Redevelopment of Loreto Kirribilli School

*State Significant
Development
Modification Assessment
(SSD-7919-MOD-1)
September 2019*

Figure 5 | Ground level floor plan showing the modified layout of Innovation Centre and walkways (red dotted outline for approved layout) identifying the major amendments (Source: Applicant's Modification report)

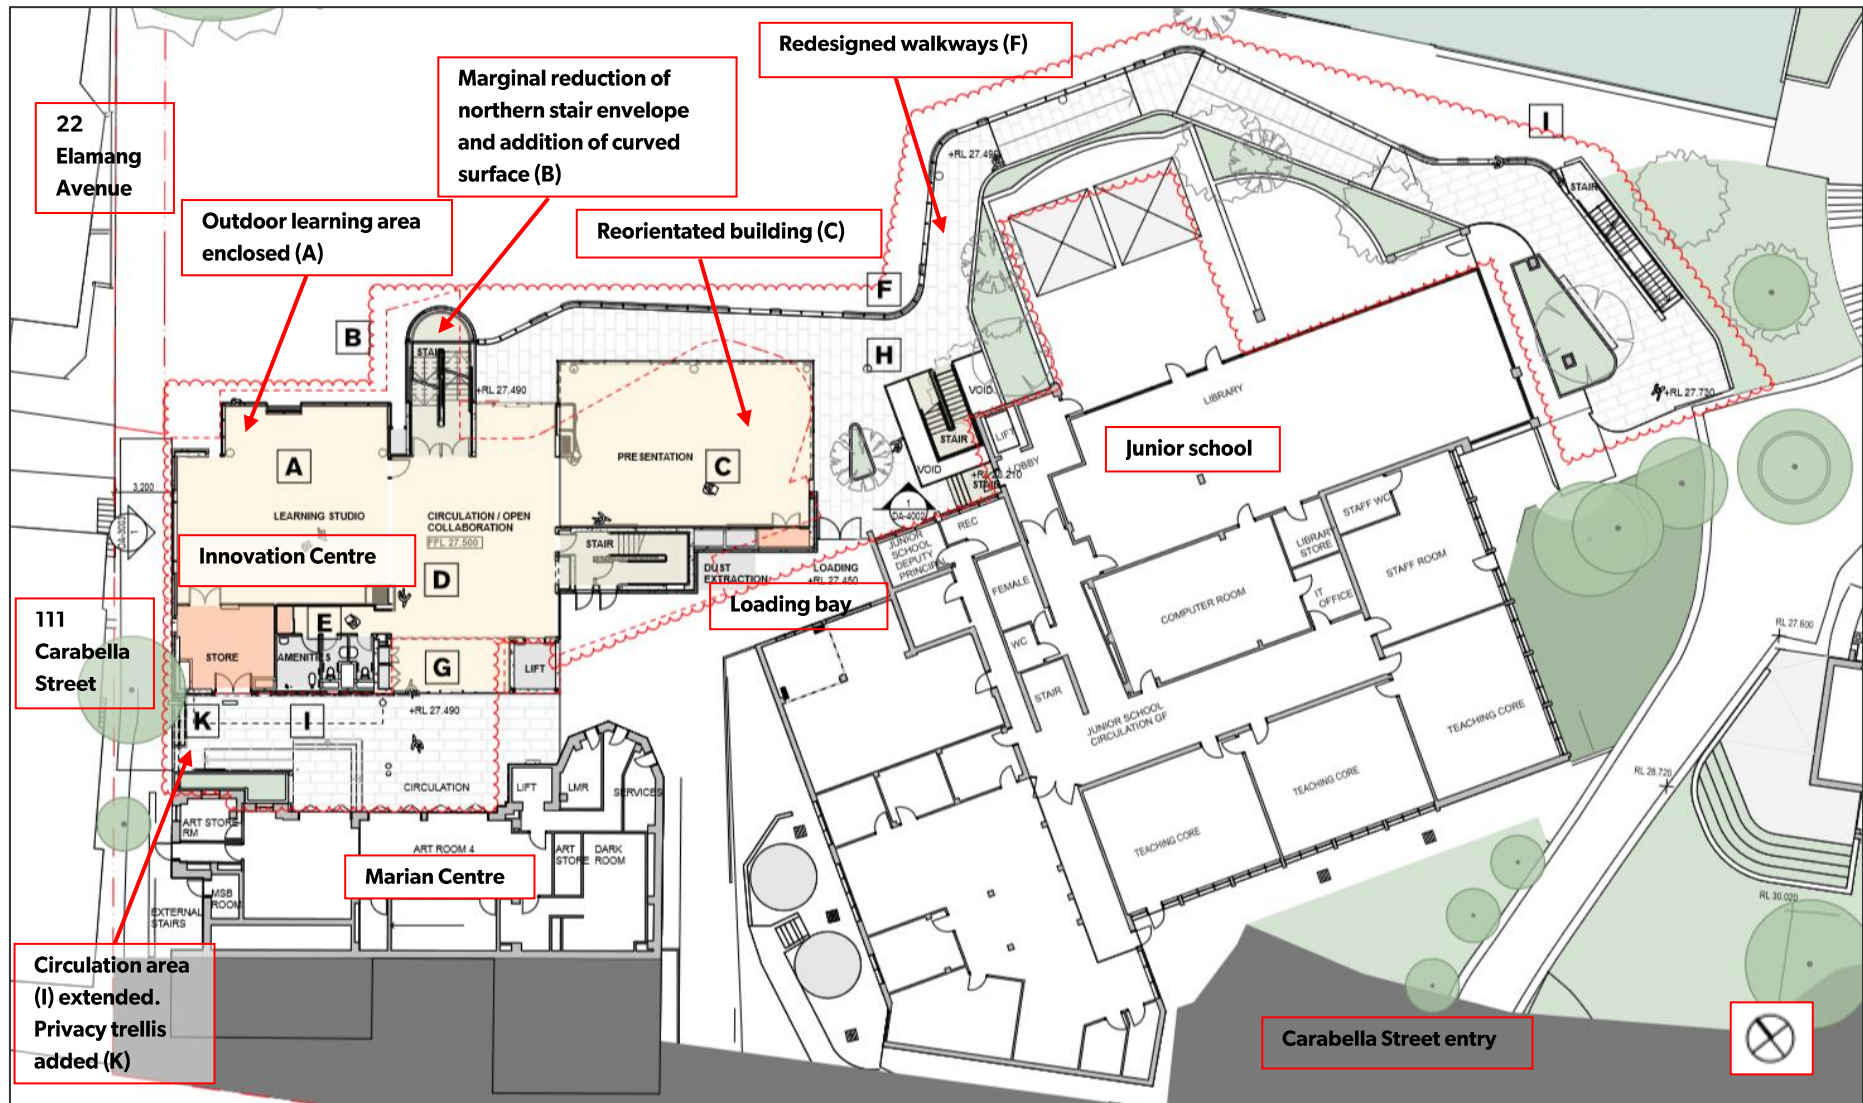
The modification also involves extension of a ground level circulation area between the Marian Centre and Innovation Centre, to the western boundary (identified in **Figure 5**). This area was inaccessible by students under the approved development. A trellis with planters is proposed at the western edge of this circulation area to retain the visual privacy of the adjoining residents to the west (**Figure 15**). The Department has assessed the submitted sight line diagrams between 111 Carabella Street and this circulation area. Based on the detailed sight line diagrams, the Department is satisfied that the circulation area would be appropriately screened by the proposed trellis and have negligible impact on the visual privacy of the adjoining residents.

Figure 7 | Modified lower ground level 4 of the Innovation Centre identifying enclosure of outdoor learning area, connection with gymnasium and modified lower ground level for Centenary Hall (Source: Applicant's additional information).

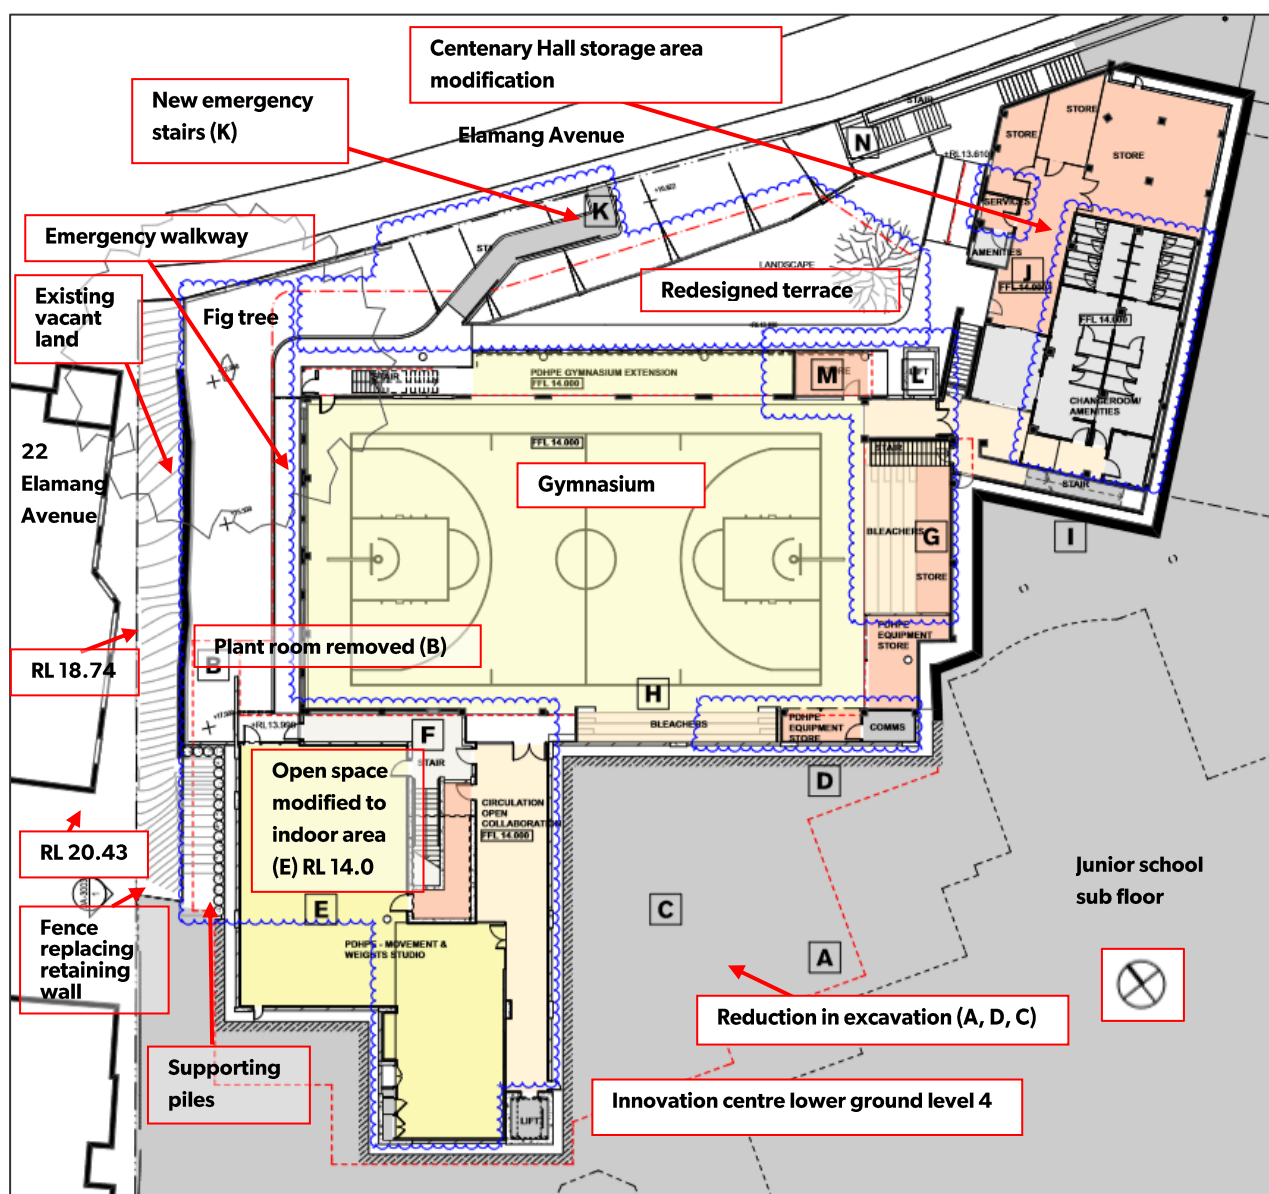
A previously approved open area at lower ground level 4 of the Innovation Centre, on the western boundary fronting the gymnasium (marked E in **Figure 7**), is proposed to be converted to an indoor learning area for personal development (PDHPE) and a weights studio. This single-storey extension to the building would be connected internally to the gymnasium. An emergency exit point at this level is proposed via an approved external walkway adjoining the western façade of the gymnasium. The rooftop would include a landscaped green space (no access for students), and conical shaped skylights with reinforced concrete for natural light to the PDHPE area below. The extension would only be partially visible from the public domain at Elamang Avenue (**Figure 9**).

The proposed modification to the gymnasium relates to internal functional aspects of this building and the external materials and finishes. An additional emergency egress stair (marked K in **Figure 7**) is proposed to cater for the gymnasium and the lower ground level 4 of the Innovation Centre. The Innovation Centre would connect to this stair via the approved walkway adjoining the western façade of the gymnasium. The modified design includes a lift for accessible connection between the Centenary Hall and the gymnasium. No changes are proposed to the approved floor levels and / or connections between the gymnasium / Centenary Hall / Innovation Centre / Marian Centre. The bulk of the gymnasium extension would be marginally reduced due to the internal redesign.

Figure 9 | Interface of the site / western boundary from Elamang Avenue (Source: Applicant's additional information)

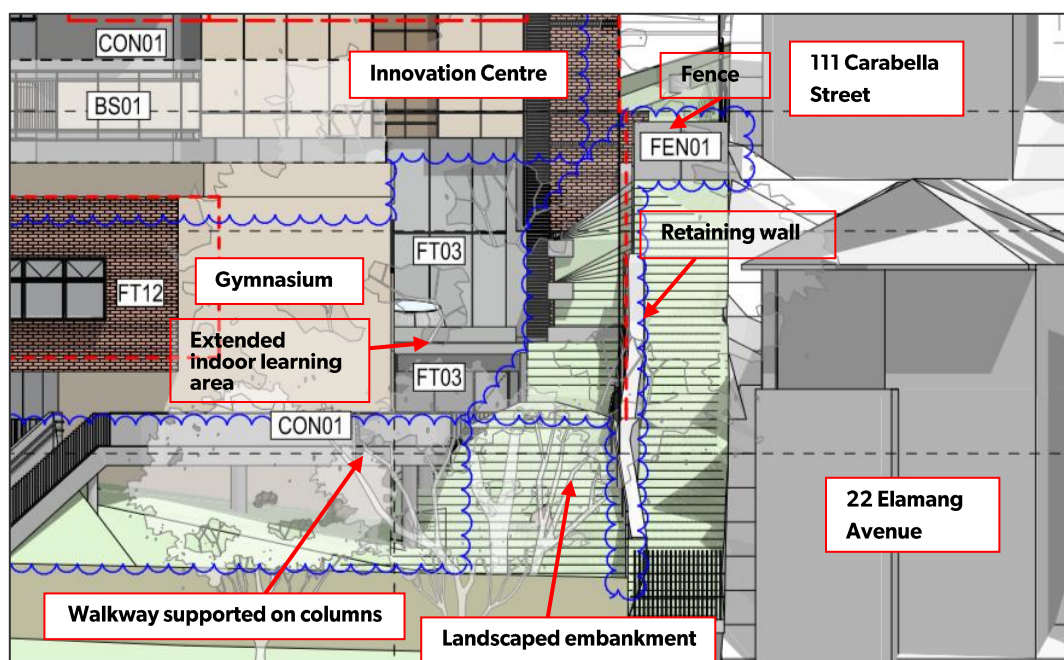
The public submission to the modification application objected to the proposed amendments on the basis that they would not result in minor environmental impacts. The submission raised concerns regarding the lack of details in relation to the visual impacts of the building bulk at lower ground level 4, rooftop landscaping and skylights as well as retaining walls on the western boundary of the Innovation Centre. The submission also indicated that the modified design may require additional demolition of the existing sandstone retaining walls on the western boundary exposing the subterranean levels of the Innovation Centre.

The Department notes the concerns raised by the objector regarding demolition of sandstone walls on the western boundary and concludes that the modified development does not propose any additional excavation works leading to exposure of subterranean levels. No additional sandstone walls are proposed to be demolished under this modification application, in addition to that approved by SSD-7919. The replacement of a minor section of the sandstone wall by a fence would have no visual impact on the property at 22 Elamang Avenue.

In response, the Applicant provided additional information confirming that the existing retaining wall on the western boundary of the site would not be modified and a new palisade fence would be proposed on top of this wall. The Applicant also advised that the majority of the existing sandstone walls on the boundary adjoining 22 Elamang Avenue would be retained with only a minor section being replaced by a new fence (**Figure 7**). The Applicant provided additional diagrams to identify the piles / retaining walls on the western boundary and demonstrate that none of these structures or subterranean areas would be visible from the western side. The interface between 22 Elamang Avenue and the modified development is identified in **Figure 9**.

In response, the Applicant submitted amended plans reducing the size of the northern terrace and relocating of the proposed emergency stairs further east of the site. The Applicant confirmed that the approved emergency walkway adjoining the gymnasium would be supported on columns (**Figure 9**) with climbing plants to camouflage the under-croft.

Figure 10 | Comparison of approved and modified views of the gymnasium / Innovation Centre from the two identified east facing windows at 22 Elamang Avenue (Source: Applicant's Modification report).

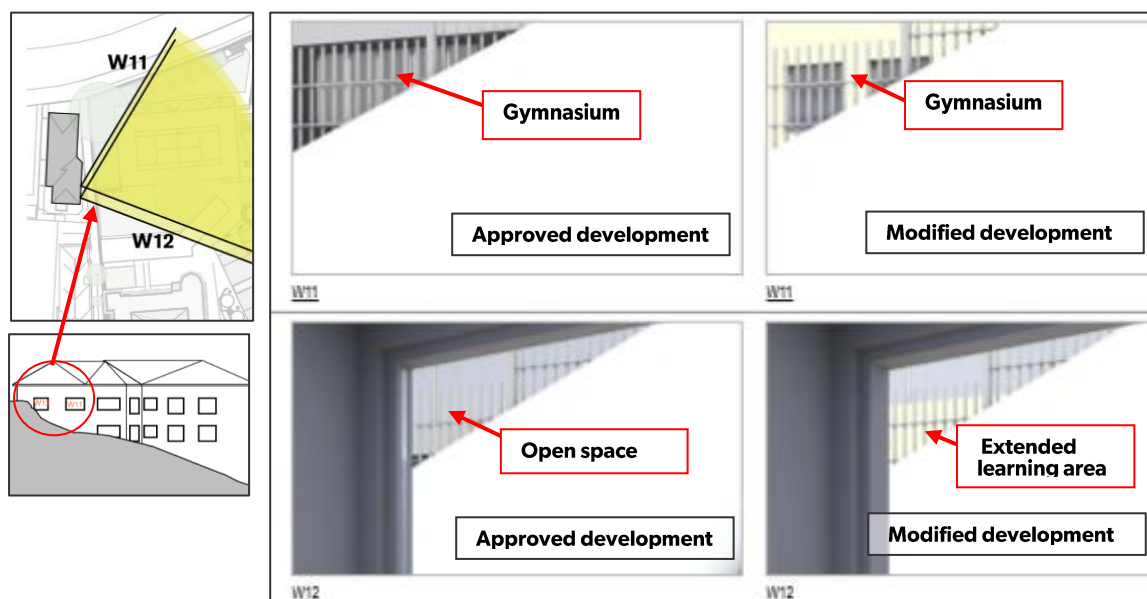
The Department has assessed the additional visual impact of the extended lower ground floor 4 on the neighbouring residents to the west. The submitted architectural plans identify that the finished floor level of the extended indoor learning area would be at RL 14 (same as approved) and the roof would be at RL 17.3 (approximately 300mm above the approved level) as identified in **Figure 8**. However, the roof would still be at a lower level than the retaining walls on the eastern boundary of 22 Elamang Avenue as identified in **Figure 9**.

The modification application is supported by an amended View Impact Assessment report (VIA), which demonstrates that the roof of the extended section of the innovation Centre can only be partially viewed from one east facing window (W12) of the building at 22 Elamang Avenue (**Figure 10**).

Based on the proposed RLs of the Innovation Centre and the above VIA, the Department is satisfied that the additional bulk due to enclosure of the open space would be perceived as a low scale single storey building from the east facing windows of 22 Elamang Avenue. As such, the two properties are well separated by a narrow (2.7m wide) vacant piece of land, which includes existing vegetation. Consequently, the increase in bulk would not have a significant detrimental impact on the neighbouring residents to the west and would be an

Figure 11 | Modified finishes in Stage 1 and relationship with surroundings (Source: Applicant's Modification Report)

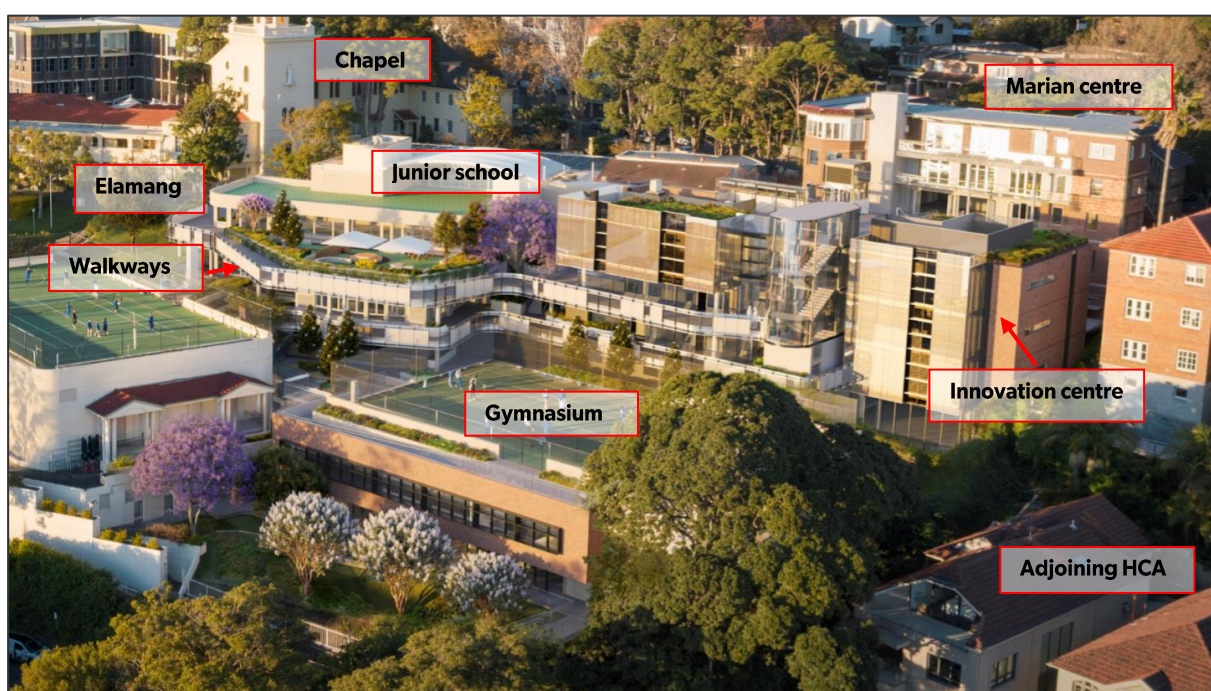
The Department concludes that while the modified materials and finishes include a greater proportion of glazing and lighter colours when compared to the originally approved building, face brick would still be used on the elevations at the interface with the adjoining HCA to complement the established character of the area. The Department agrees with the conclusions of the Applicant's HIA and is satisfied that the proposed materials and finishes would not compromise the significance of the existing buildings on the site or the HCA.

The Department has assessed the modified materials and finishes of the gymnasium and considers that the proposed face brick and the lighter colour at the interface with the adjoining buildings is an improvement over the previously proposed off-form concrete surfaces. The additional glazing on the Elamang Avenue elevation would generally blend with the surrounding buildings on the site and the adjoining HCA (**Figure 11**).

Figure 12 | Comparison of approved (left) and modified (right) chapel floor plan (Source: Applicant's Modification Report)

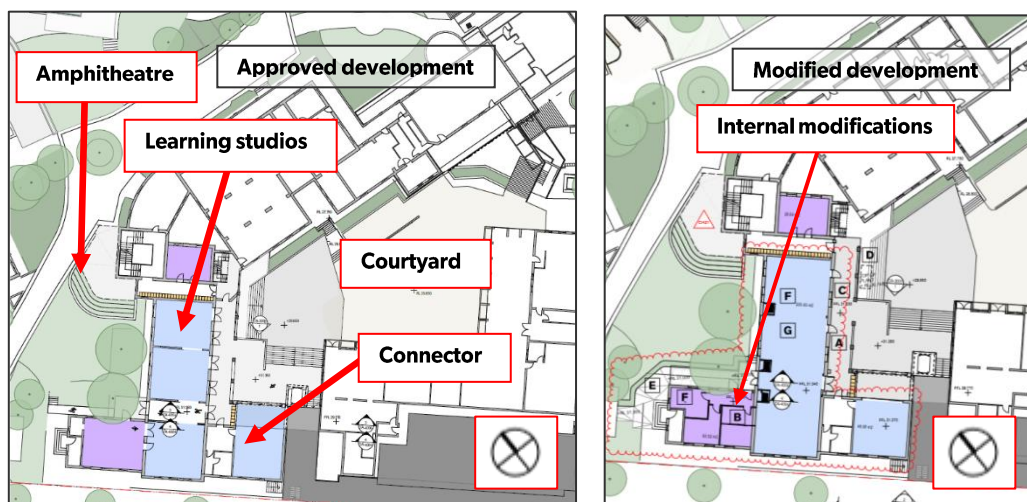
The Department has assessed the internal alterations which relate to windows / fit-out for air conditioning and the addition of walls to some of the functional areas. The Department is satisfied that the proposed amendments are internal and would have no additional impact on the heritage significance of the chapel.

Figure 13 | Modifications to Stage 1 landscape masterplan (Source: Applicant's Modification Report)

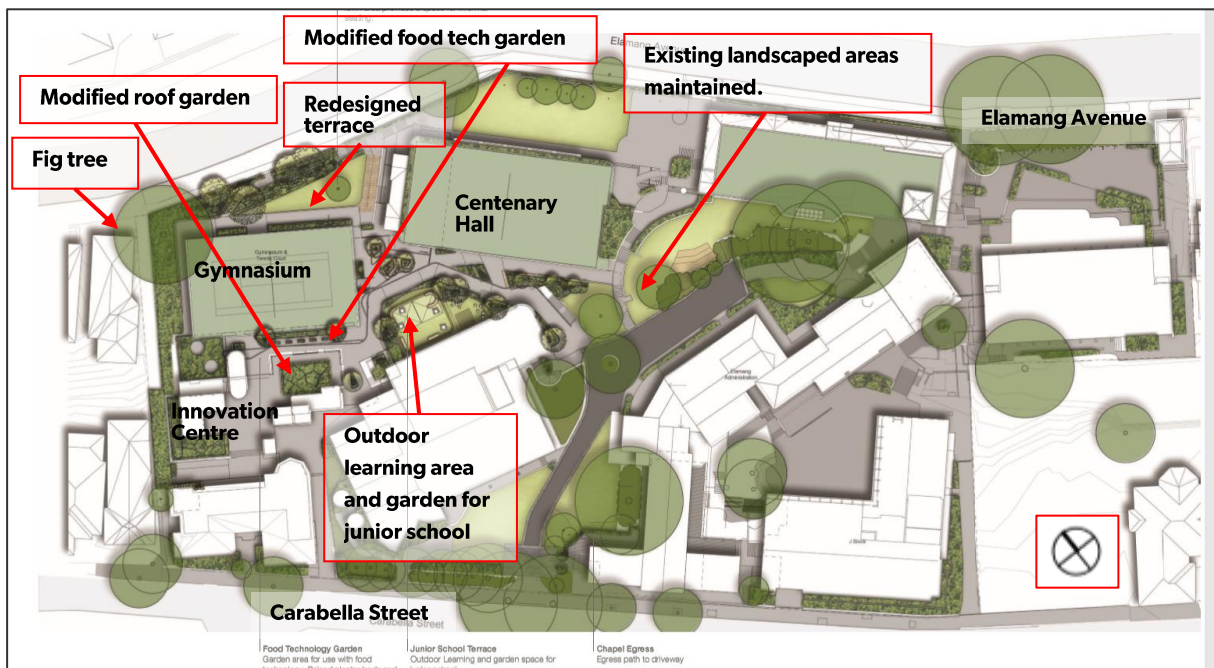
The objector requested additional information regarding the proposed landscaping along the western boundary of the site at its interface with 22 Elamang Avenue. The submitter also requested that soft landscaping opportunities along the Elamang Avenue frontage and specifically the north-western corner be increased to ensure retention of the existing fig tree on the site in the long term.

The Department's assessment of the proposed landscape modifications concludes that the proposed amendments are minor and would not have a significant impact on the overall approved site masterplan. The

In response, the Applicant submitted a revised landscaped plan reducing the size of the northern terrace to the gymnasium, thereby increasing the landscaping opportunities at the north-west corner. The Applicant also confirmed that the landscaping on the western boundary, as approved, incorporates an embankment generally maintaining the natural ground levels with a fall towards the Elamang Avenue frontage. The landscaping along the western boundary is not proposed to be modified under this application.

Figure 14 | Views from the living room window at 9/111 Carabella Street (Source: Applicant's Modification Report)

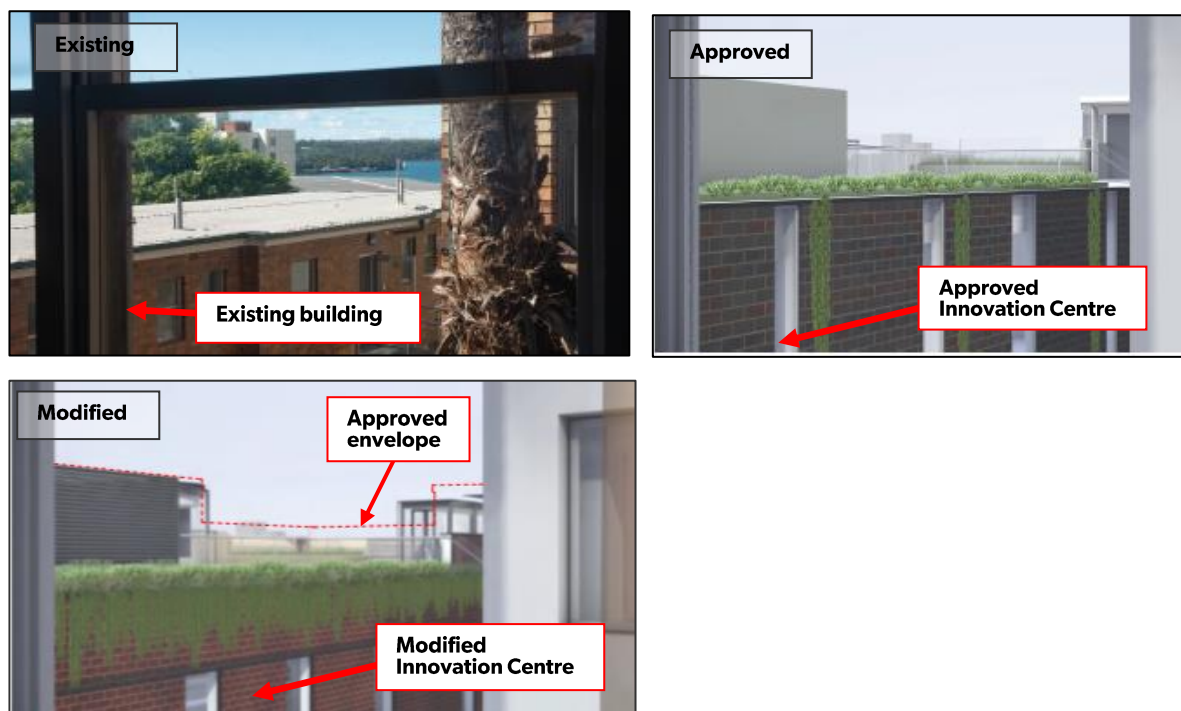
To assess the impacts of the proposed modifications, the amended VIA includes a comparison of the views of the existing building, the approved and modified Innovation Centre from the living room window (most impacted) of unit 9/111 Carabella Street. (**Figure 14**). The VIA concludes that the modified development would have negligible to nil additional impacts on the remaining sky views of this unit.

The Department has considered the additional analysis submitted in the Applicant's VIA. The Department is satisfied that the modifications to configuration and orientation of the Innovation Centre would not result in additional impacts on the residual views that would be available to unit 9/111 Carabella Street in the future.
